Awel y Môr Offshore Wind Farm

Application Errata List (Tracked)

Deadline 8

Document Reference: 8.39

FIGURE NUMBER:
Figure 19

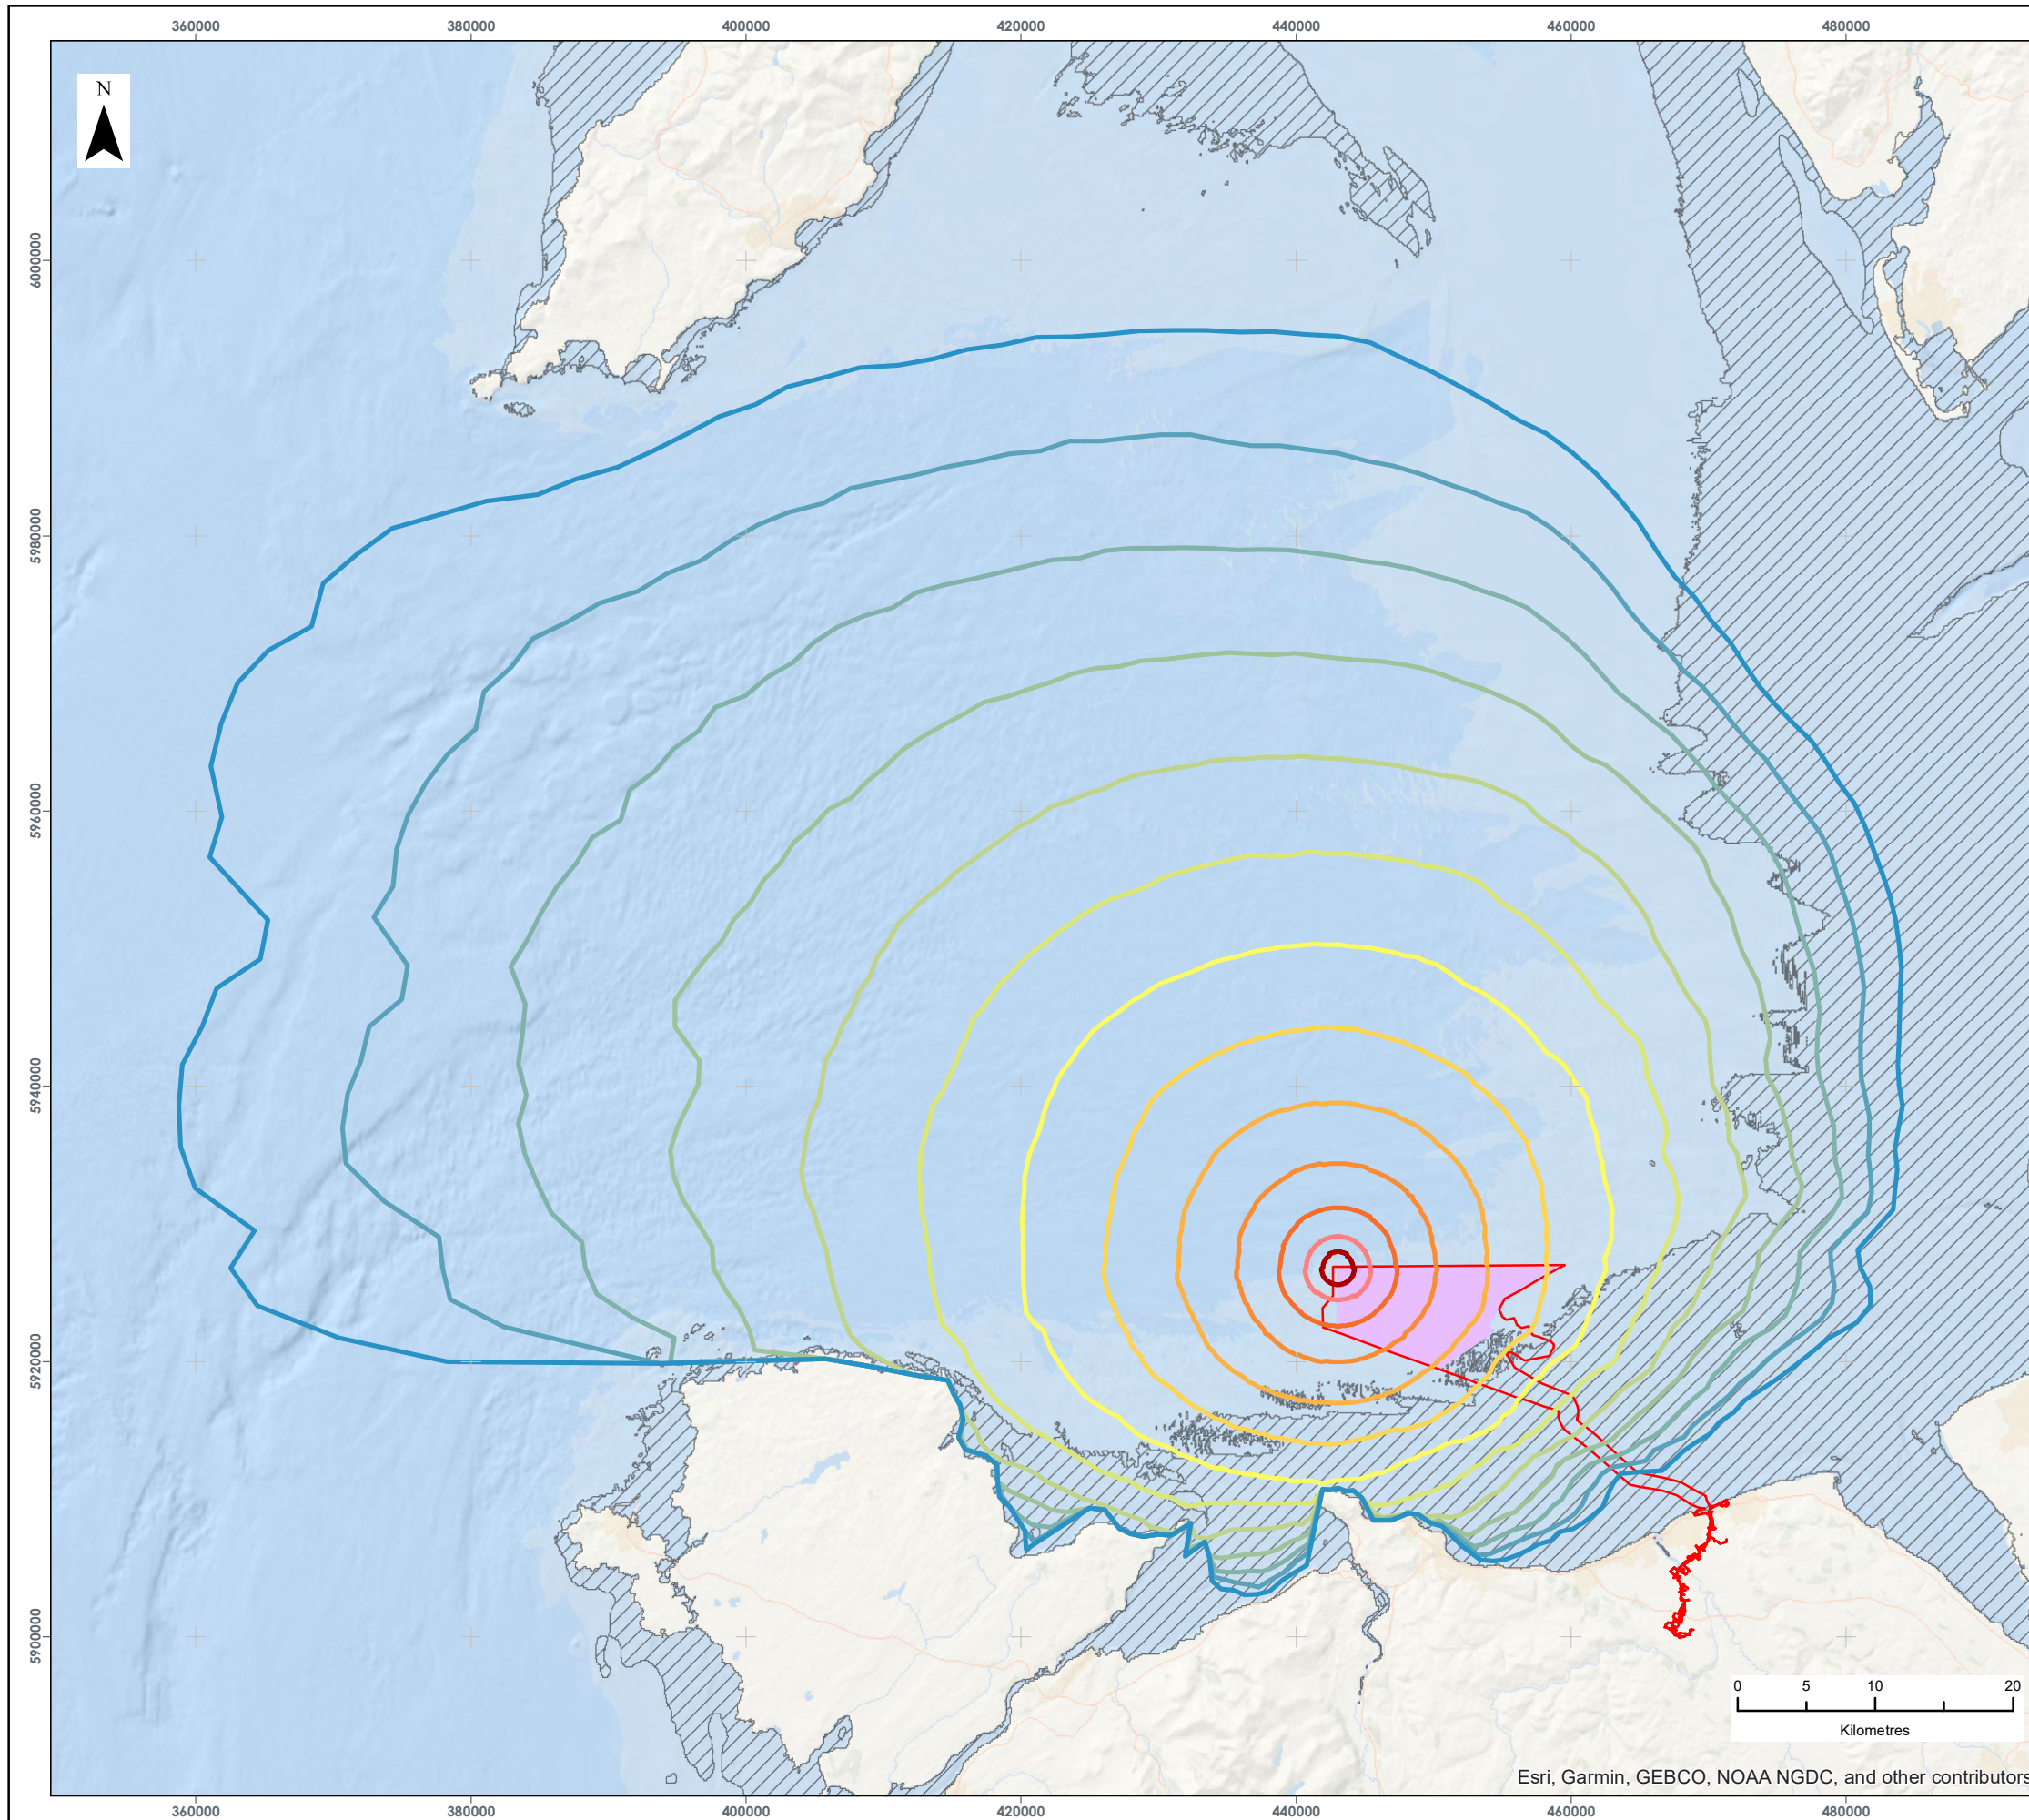
- ▲ Figure 19: Figure missing from AS-026 with Figure 21 incorrectly presented in its place. Corrected figure provided in Appendix A of this document. Note this figure is identical to Figure 19 presented in APP-053.

78 For completeness, the correct figures are appended to this document in Appendix A, duplicated from the figures presented in APP-053:

FIGURE NUMBER:
Figure 21

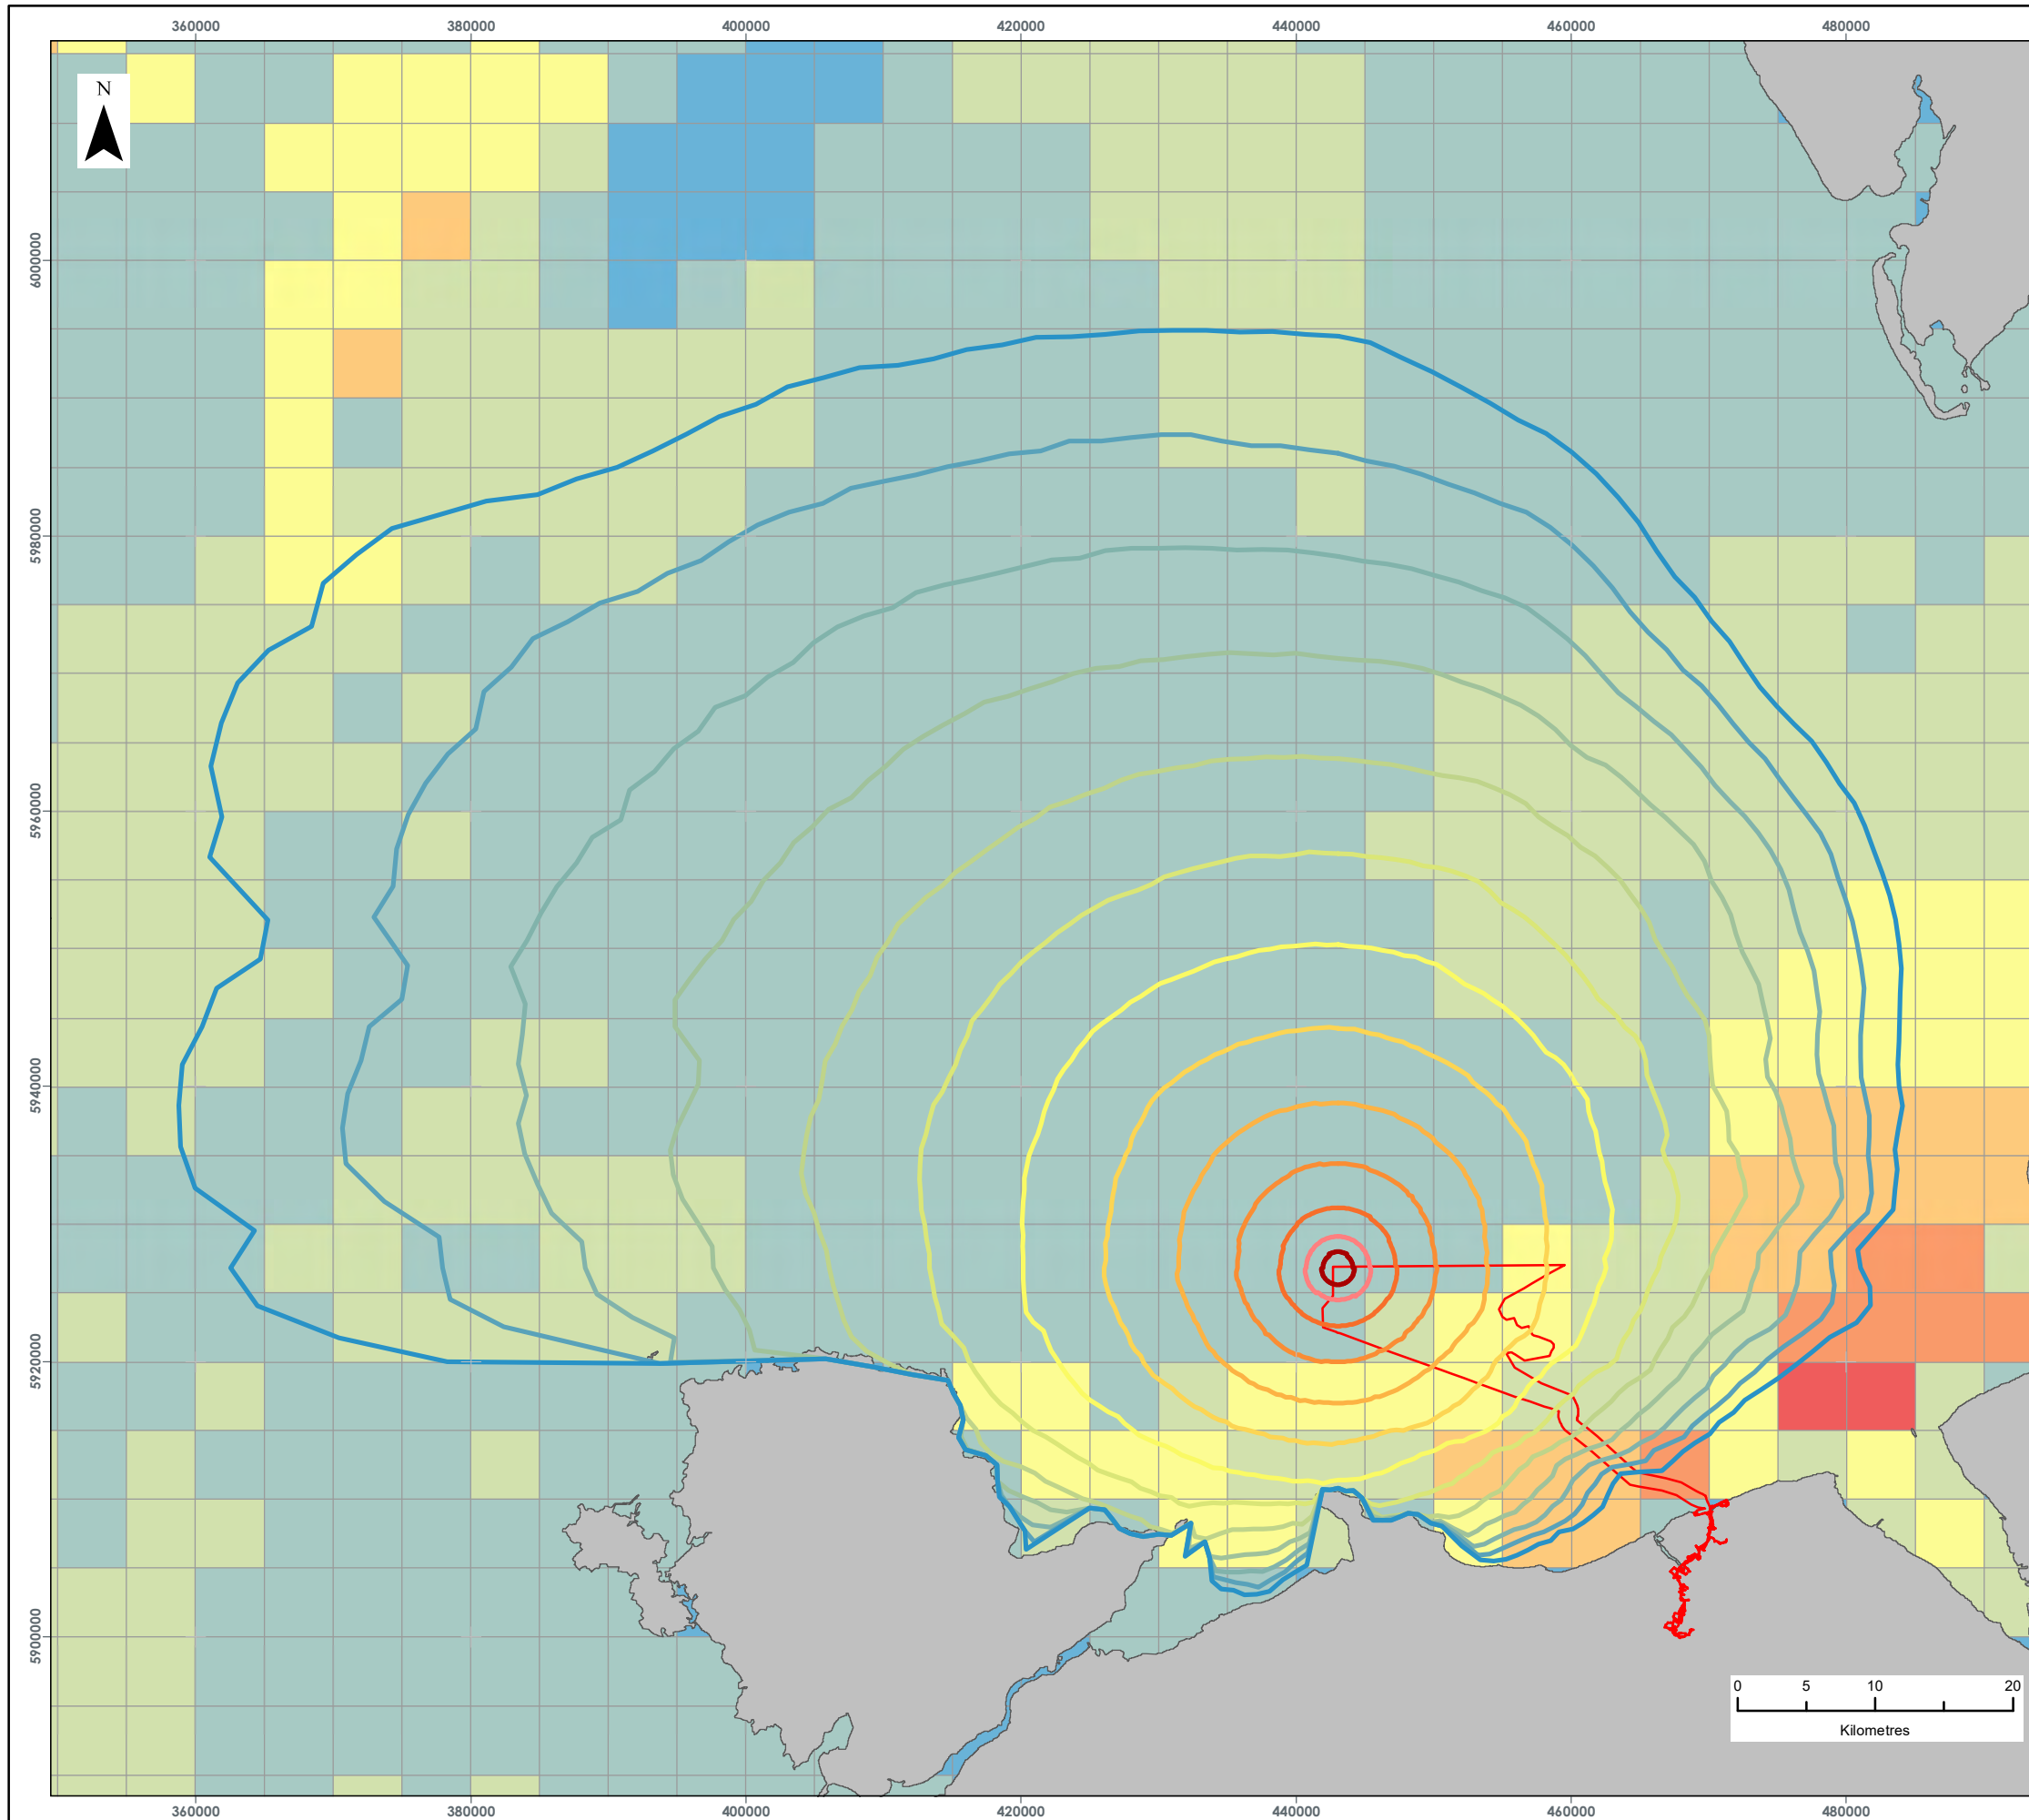
- ▲ Figure 21: Figure incorrectly displayed a partial black background and omitted base mapping. Figure was incorrectly presented in place of Figure 18. Corrected figure provided in Appendix A of this document. Note this figure is identical to Figure 21 presented in APP-053.
